Troy School District

**RFP #2425-09 - Addendum #1
BP#2B High School Athletics - Phase #2
January 21st, 2025**

Troy Schools District – RFP #2425-09 BP#2B High School Athletics Renovations - Phase #2

Addendum #1 Bidder Clarifications

LD1.01

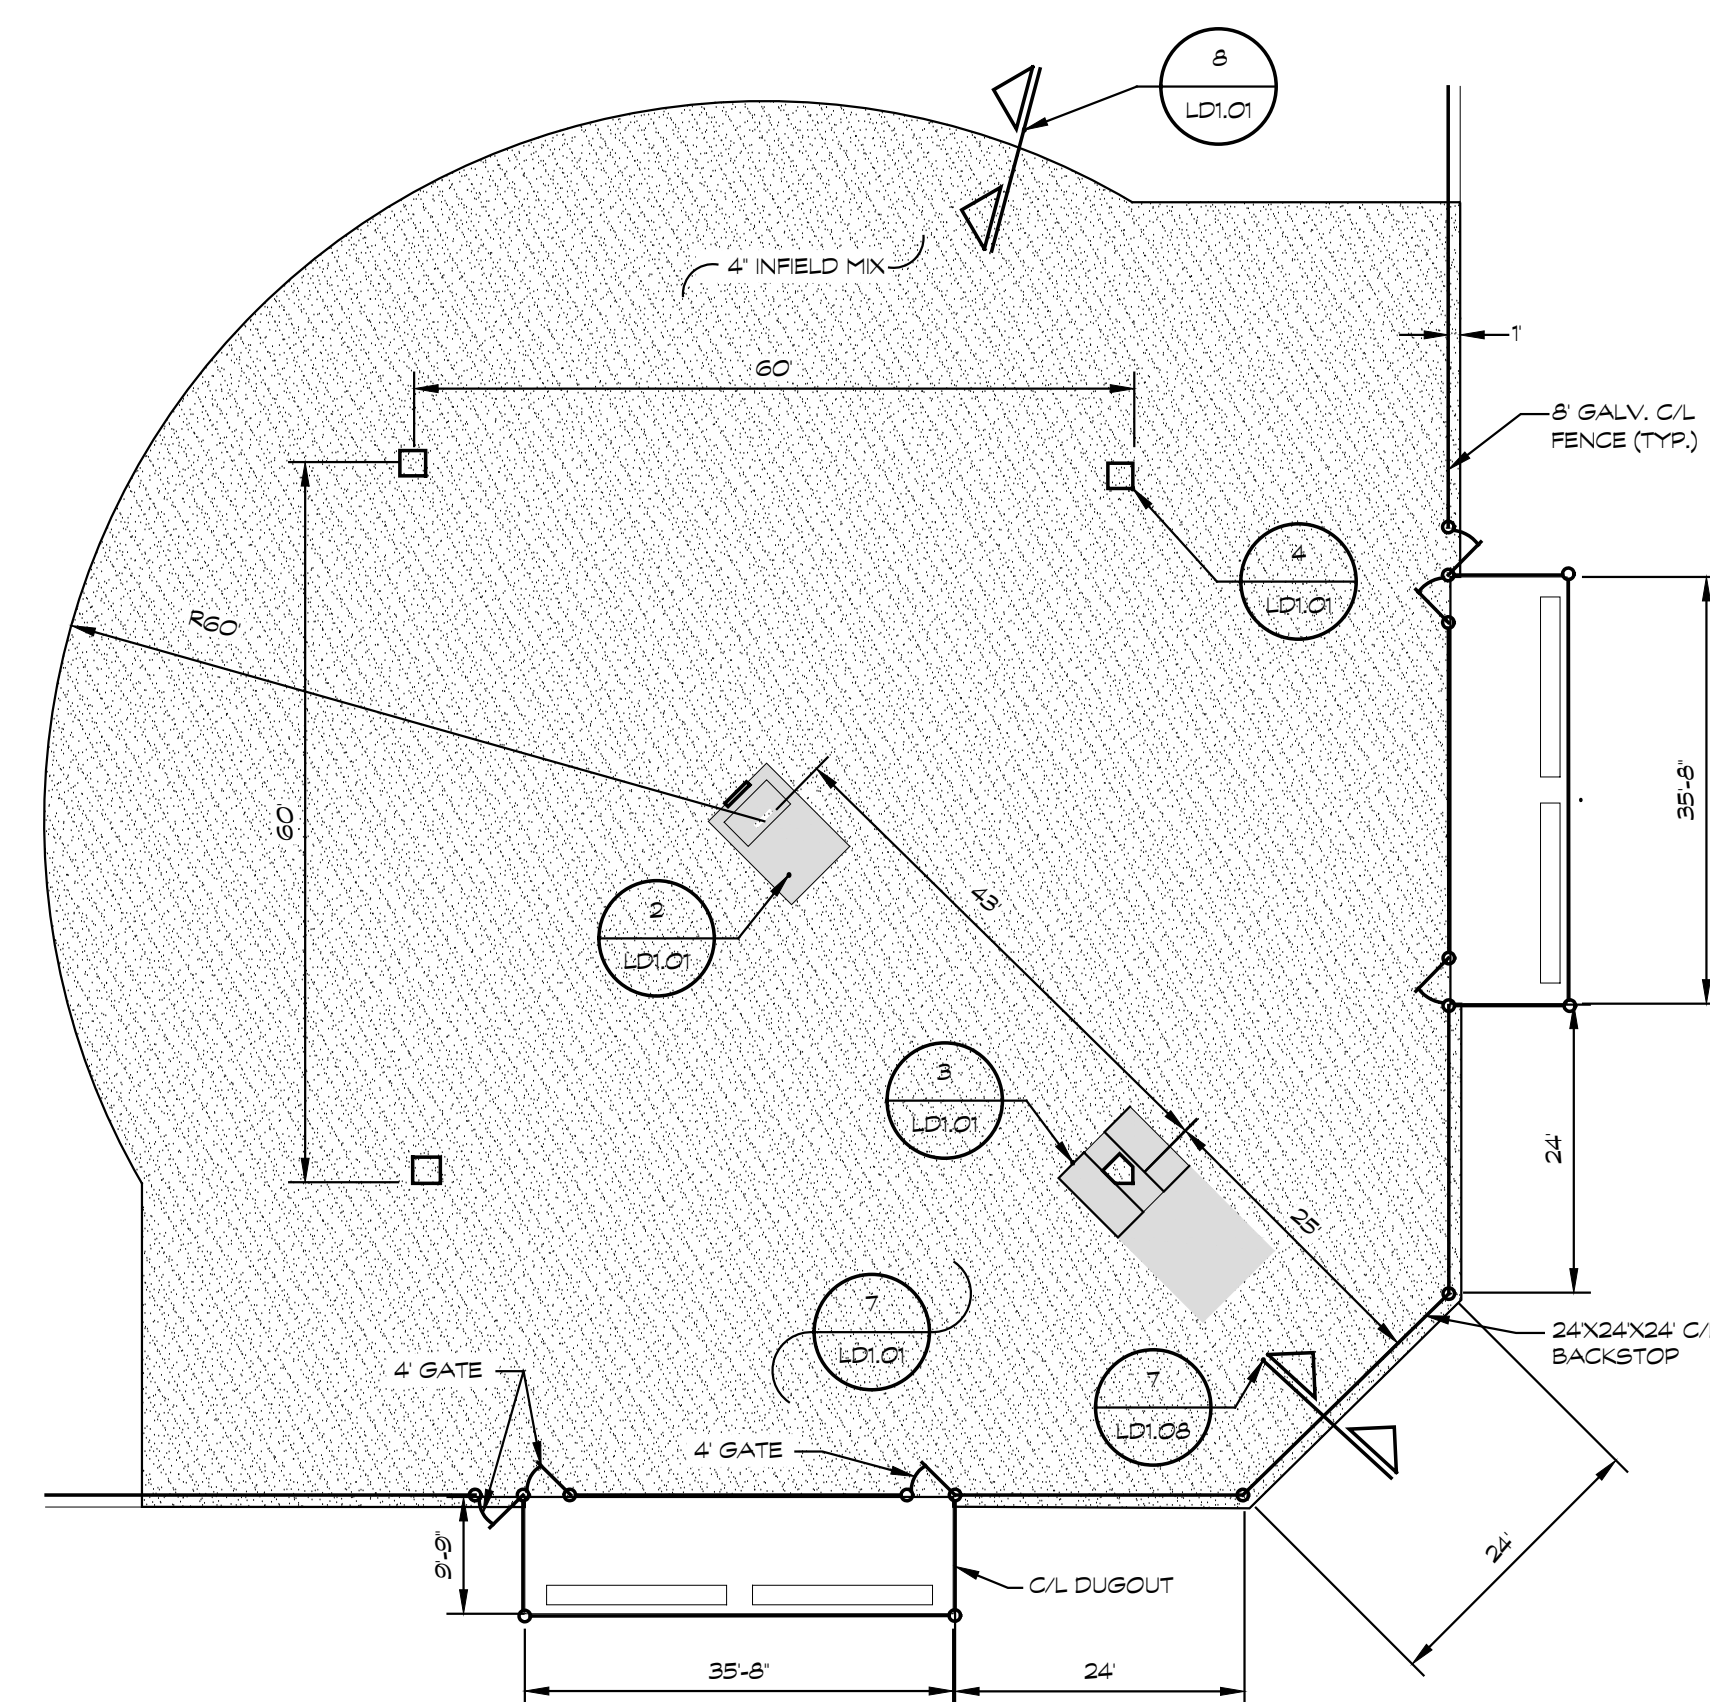
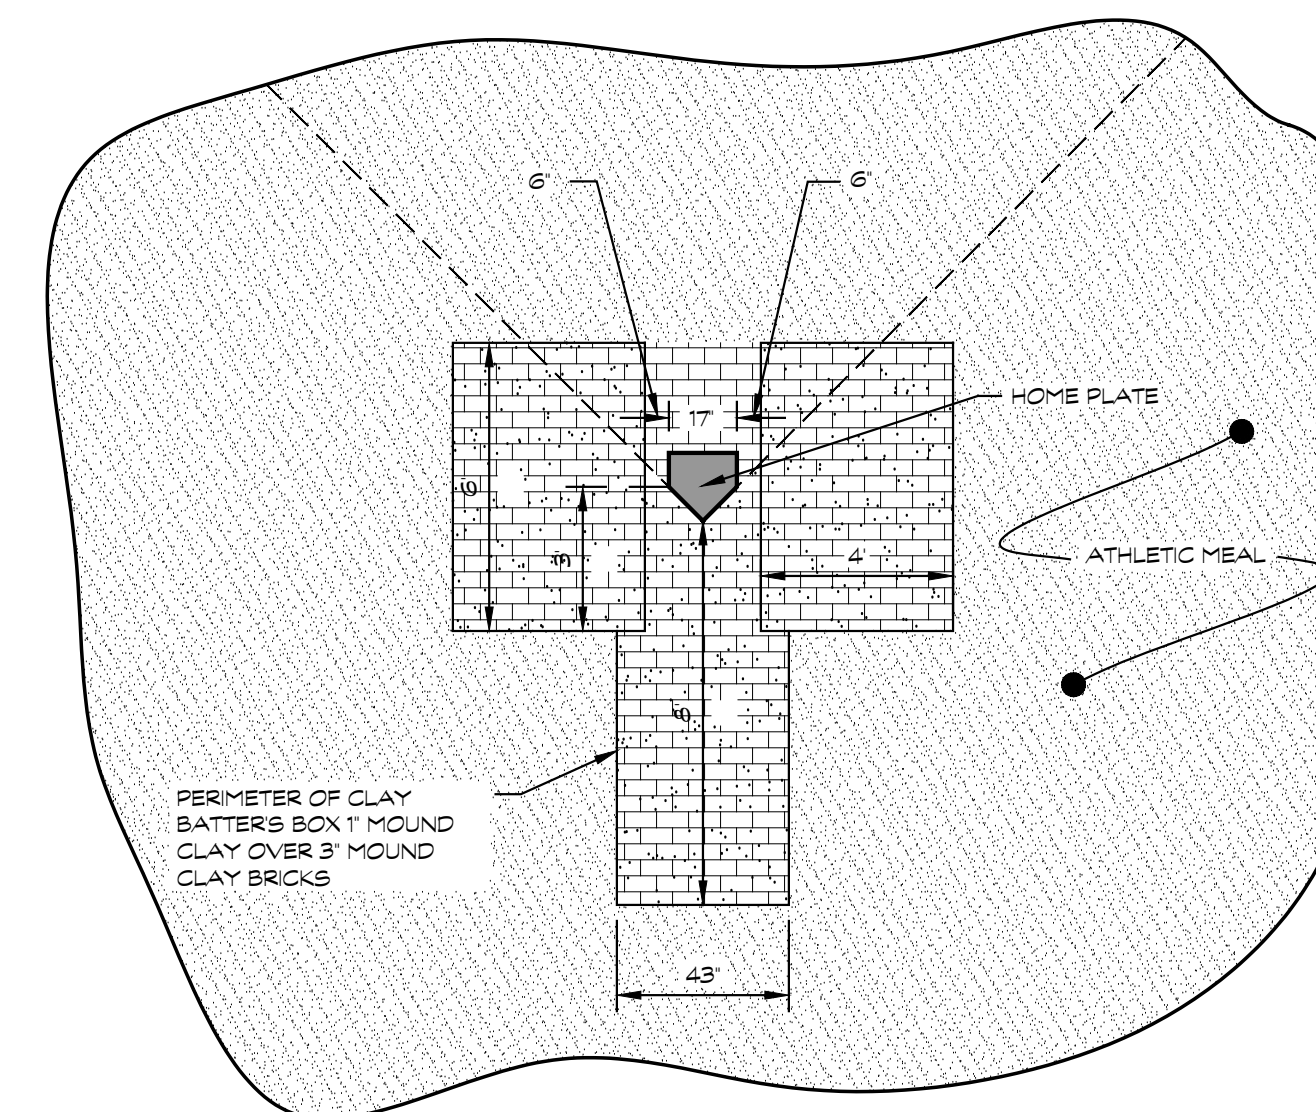
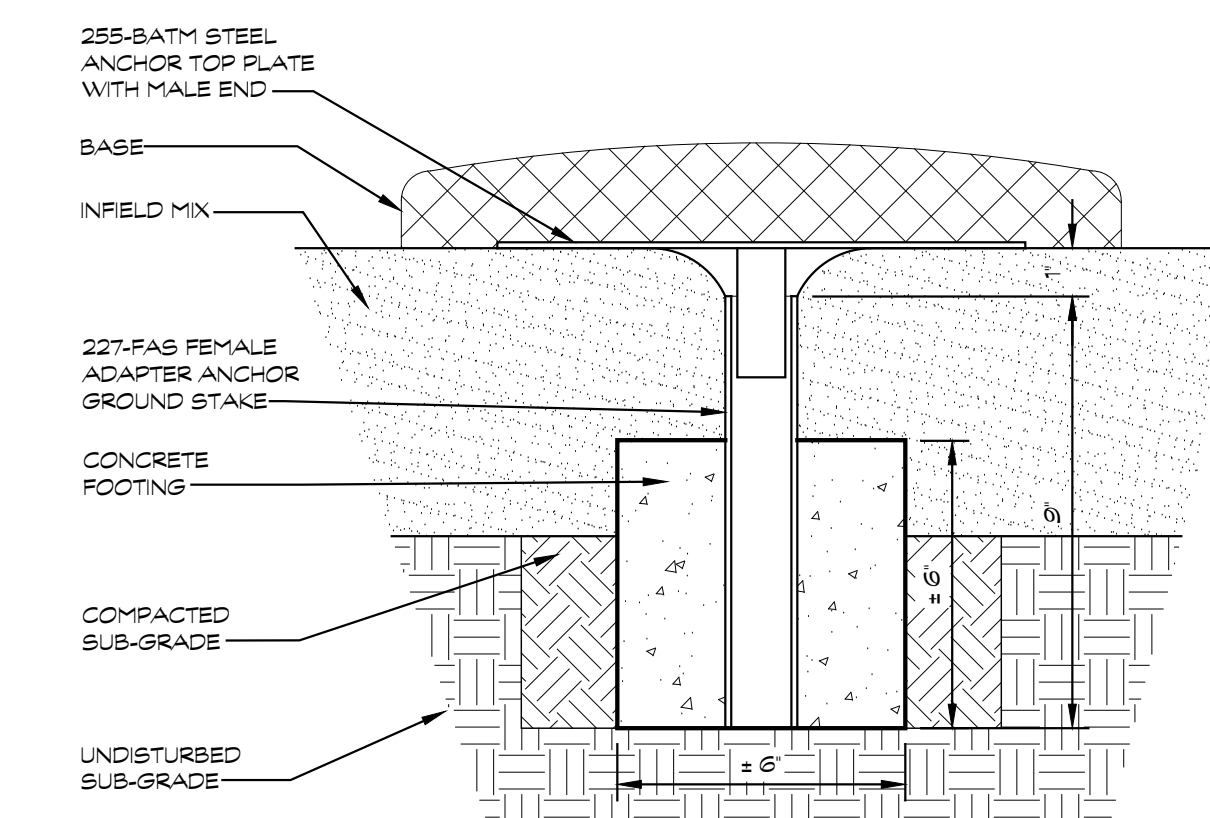
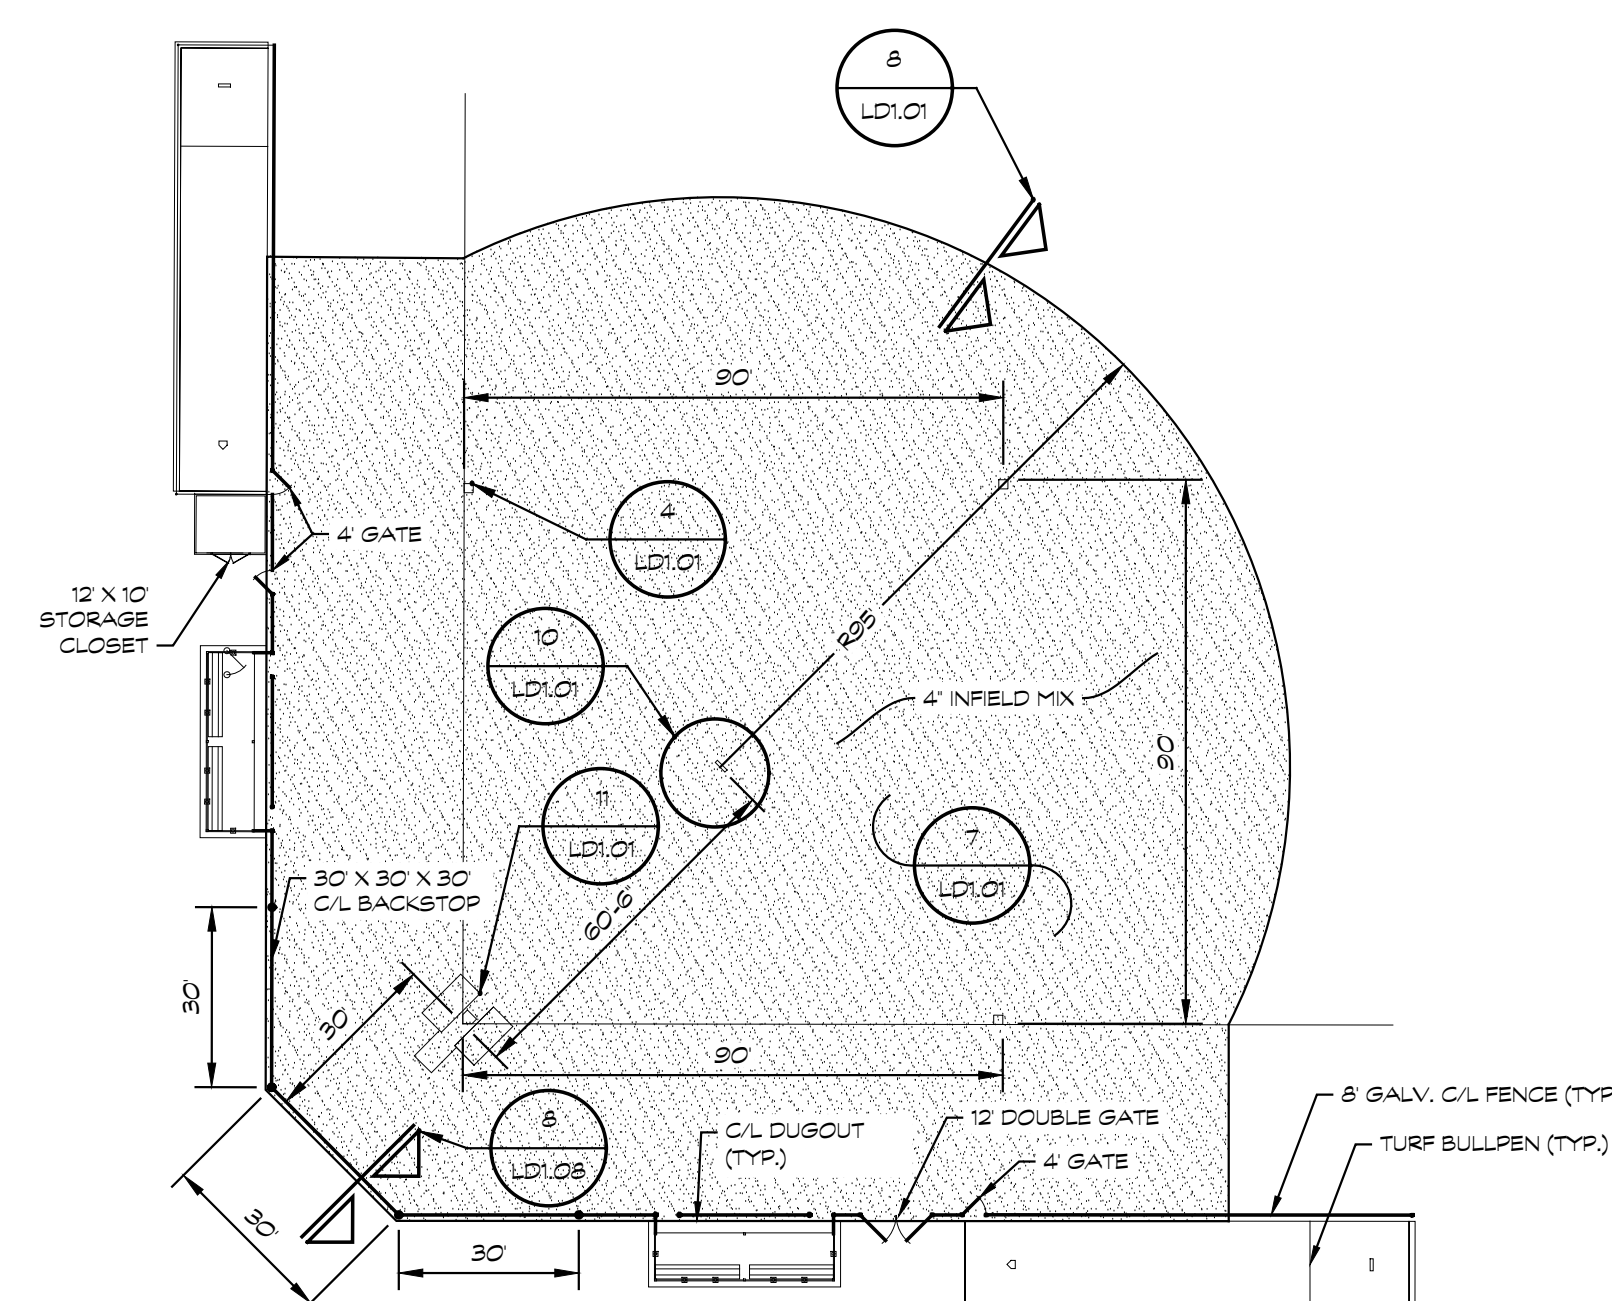
- LD-6 Refer to Drawing No. LD1.01 (reissued):
 - A. Added details to further communicate JV ballfield design intent as indicated.
 - B. Revised details; moved scoreboard details and flag pole detail to a different LD sheet as indicated.
